## **CONSTRUCTION SUMMARY**

## Lindsay 2017 Developments Inc. / Sugarwood

Lot/Unit: 177 Block 94 Phase/Building: 1 Model/Floor Plan: Balsam Lake(2003)Elev A 3Bed 2.5Bath

Sketch#1

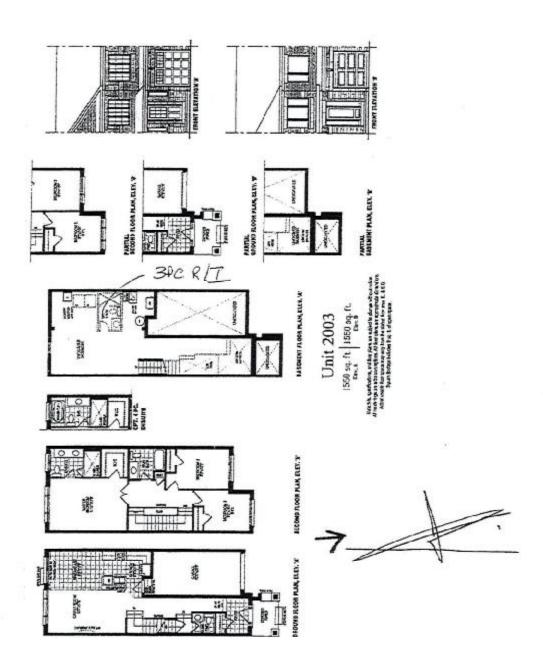
Inv. <b>5514</b>	1 - To supply & install the 3pc. rough in in the unfinished basement see sketch # 1	
Line 70507	Note:	
29Mar22 / 29Mar22
